Subject of this Document: Survey of Radioactivity - Monitoring Practices  
at a Boiling Water Nuclear Power Station.

Type of Document: INTERIM REPORT

SURVEY OF RADIOACTIVITY - MONITORING PRACTICES  
AT A BOILING WATER NUCLEAR POWER STATION

Revised April 1978

Figure 12 - Secondary Containment Exhaust Monitor Line

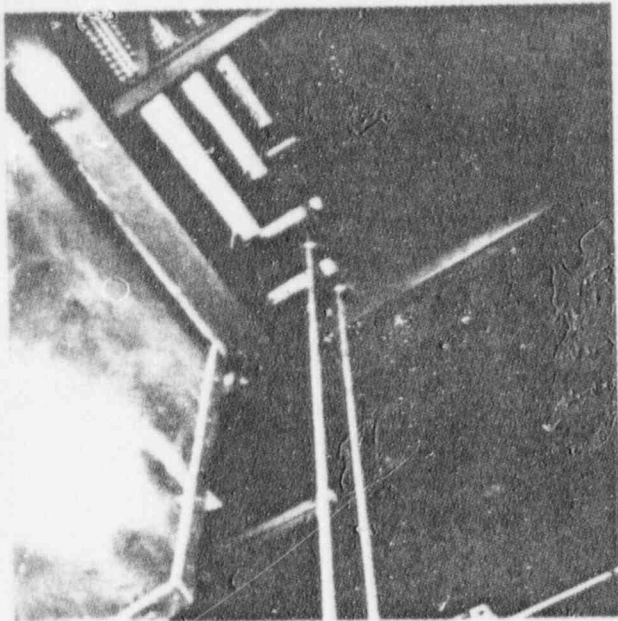
Most of the ventilation air monitors are installed at locations necessitating long vertical sampling lines (see Figure 12). While this is contrary to ANSI Standard "preferred practice",<sup>(4)</sup> it does not appear practicable to install monitors adjacent to roof vents of high bay buildings. From the information accompanying the ANSI Standard and considering the flow rates and sampling line size, significant line losses of particulates would not be anticipated. However, the plant radio-chemistry group assumes a 20% line loss for particulates in their calculations of release concentrations and amounts.

b) Sampling Line Losses: Although the plant radiochemistry group appears to have taken a conservative position with regard to sampling line losses, it is not based on empirical data (aside from one comparison for radioiodine at the stack). In the literature, we have encountered a study made at a pressurized water reactor in which one set of particulate and charcoal filters was placed at the stack and another 66' downstream in a 2" sampling line, at a flow rate of 1 cfm. For a weekly sample, the line losses were: Gross Beta 46%,  $^{58}\text{Co}$  40%, and  $^{131}\text{I}$  74%.<sup>(11)</sup> This suggests that an assumed line "loss" factor of 20% may not be sufficiently conservative. It appears that most of the  $^{131}\text{I}$  in a BWR stack effluent should be in the form of methyl iodide, with a low deposition velocity (particularly at a BWR with an advanced off-gas treatment system). However, most of the radioiodine in the building ventilation should be in the elemental form,<sup>(12)</sup> which would be most prone to line losses. Since long sampling lines are more the rule than the exception at operating nuclear power stations, we recommend that a general study of such losses be made so as to better define their extent under various plant operating conditions.
